United States Department of the Interior

BUREAU OF LAND MANAGEMENT

Re: Minor Modification, Resource Recovery and Protection Plan (R2P2), 6th East and West Right-of-Way, Crandall Canyon Mine

Approved Mine Map

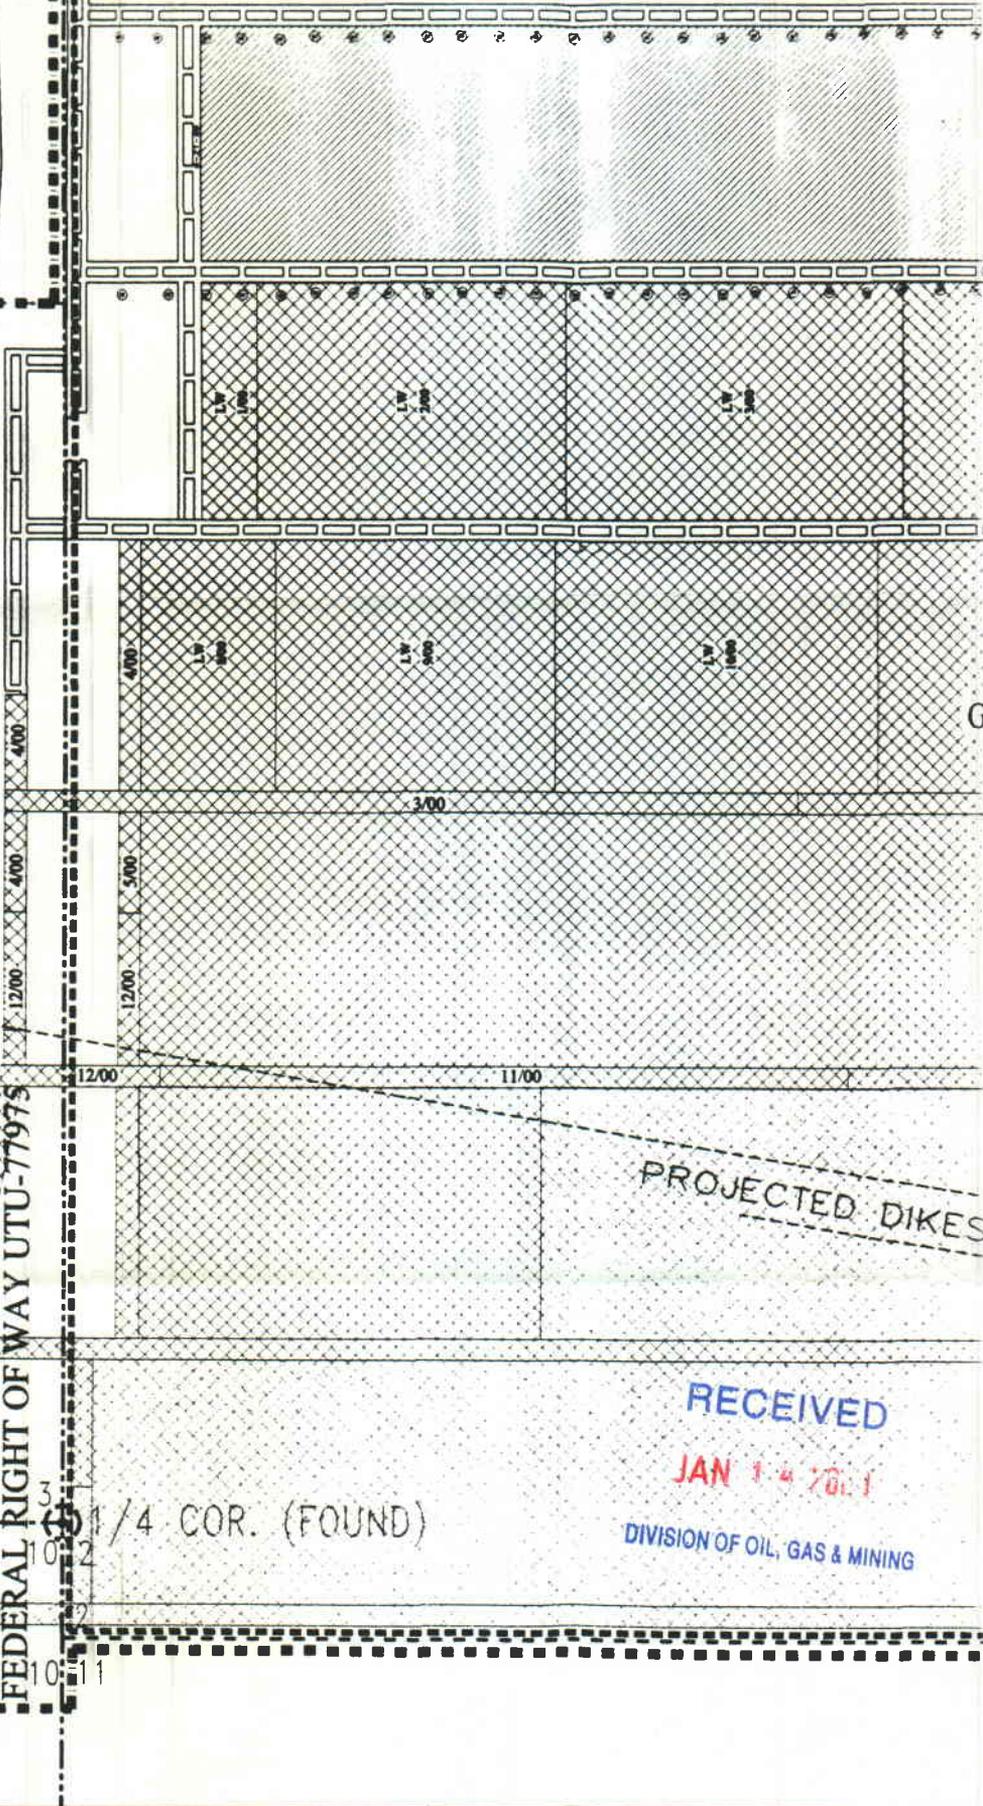
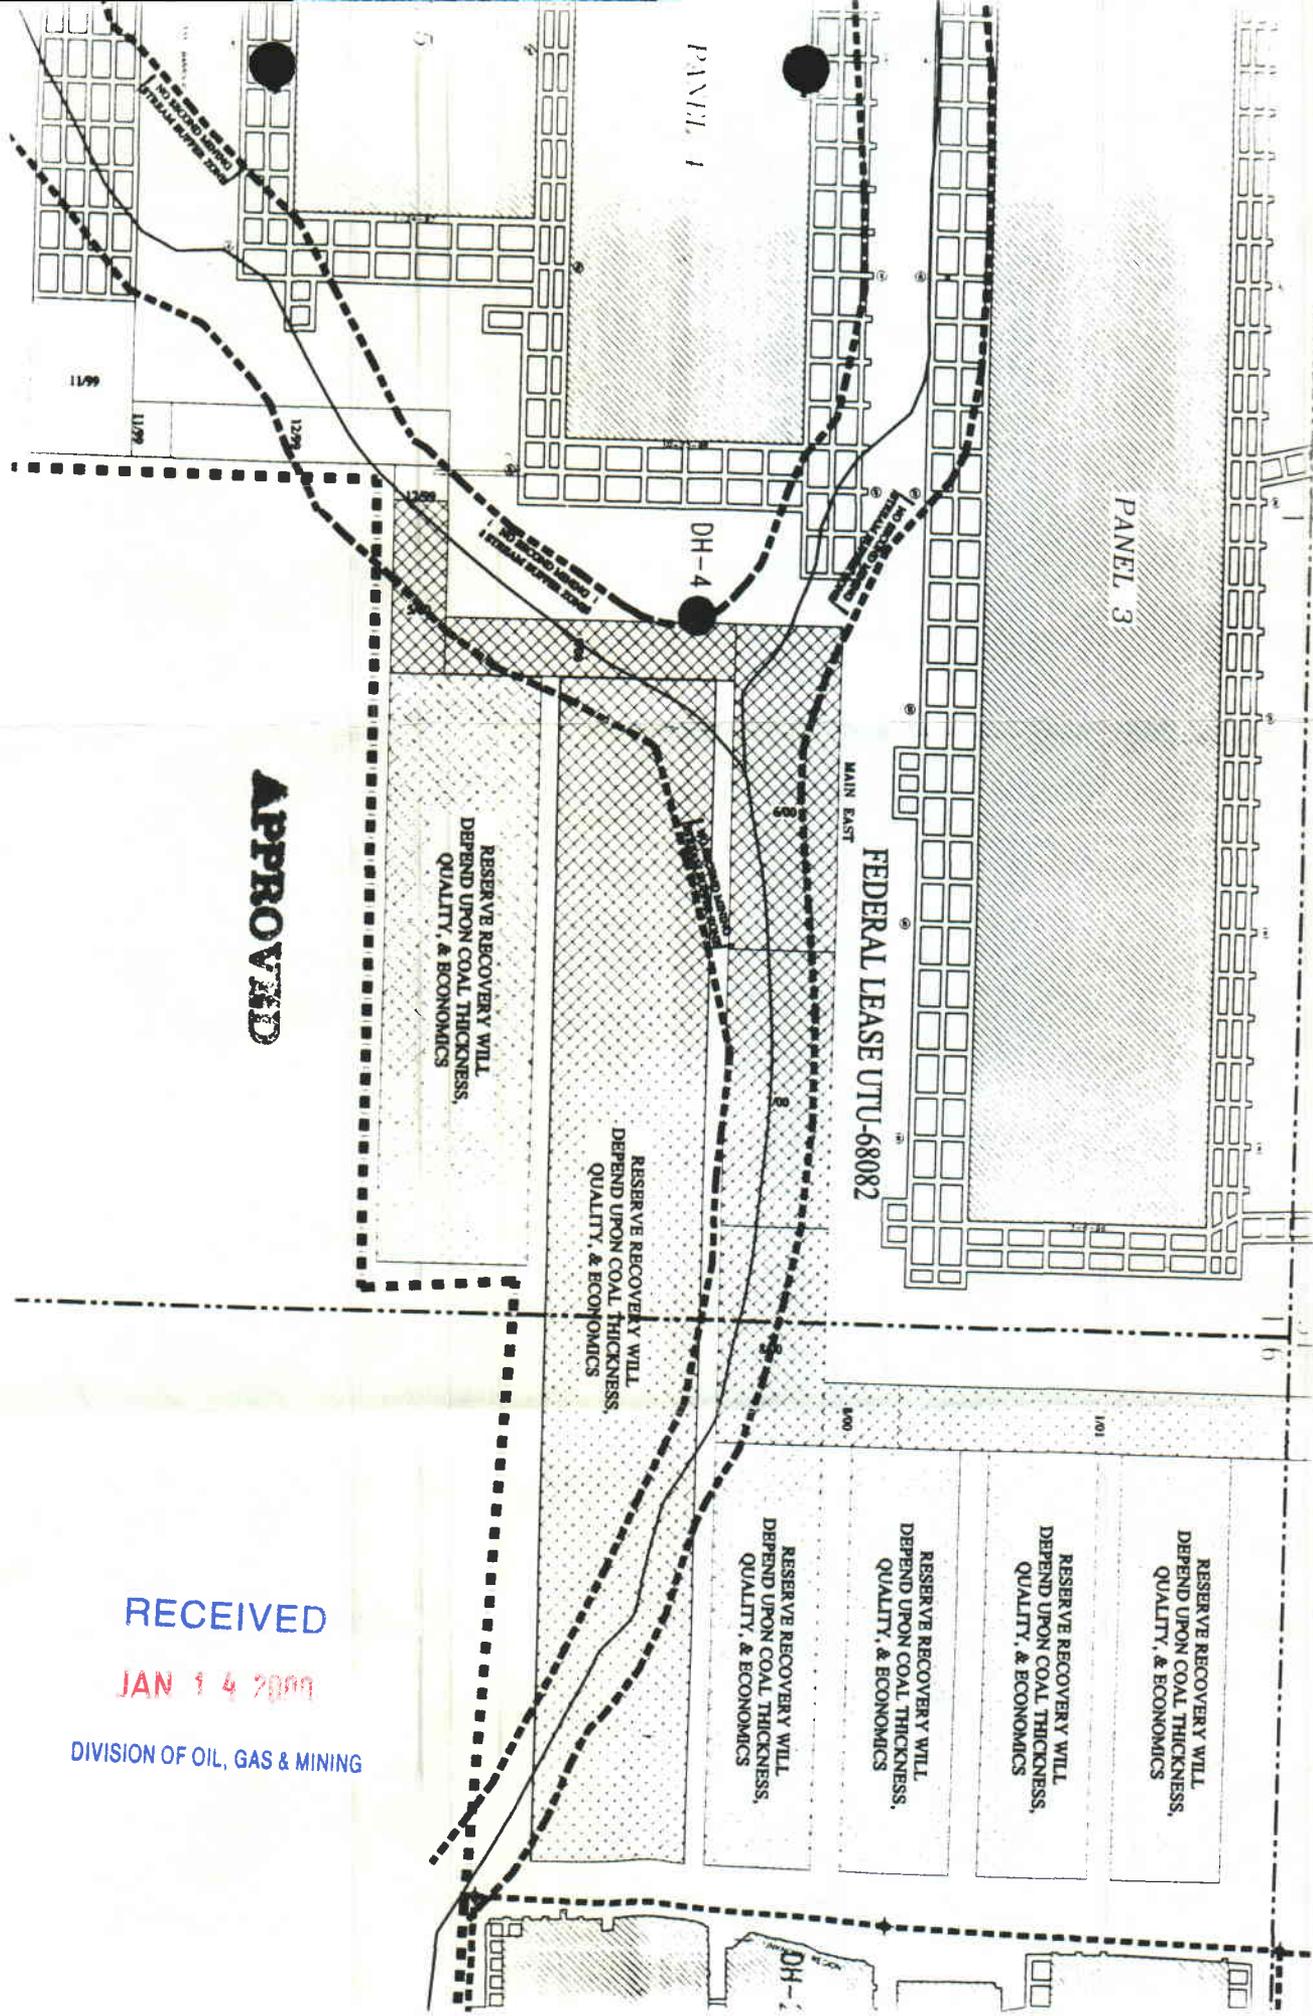
The BLM agrees with Genwal with the projected location of the fault and encourages greater recovery by establishing a coal right-of-way in this narrow strip to provide for the bleeder entries for the longwall panels. The widening of the longwall panels involve State lands where we have no direct jurisdiction. However, the widening of the longwall panels would place the south-most

panel within proper distances to the boundary with another owner to the south. The bleeder entries in the right-of-way are configured to the widened panels. With regards to the mining layout east of longwall panels 3 through 5, the changes reflect the need to access the area via entries north off 6th East along the southeast boundary, as the new Mill Fork Lease Tract is now controlled by another lessee. The room-and-pillar panels are laid out logically with all areas projected for mining as coal quality and thickness allows. The BLM concurs with the layout and configuration of room-and-pillar panels in this area. Genwal is authorized to mine this area to the limits of coal quality and thickness, as the BLM agrees that the exact areas of minable coal is unknown. This approval notes that Genwal will not mine full extraction in the Crandall Creek buffer zone.

Genwal's proposed changes to the R2P2 complies with the Mineral Leasing Act of 1920, as amended, the regulations at 43 CFR 3480, the lease terms and conditions, and will achieve maximum economic recovery of the Federal coal. The mining layouts in the west right-of-way and the southeast portion of the mine (behind longwall panels 3 through 5) are approved as submitted. A copy of the approved mine map is enclosed.
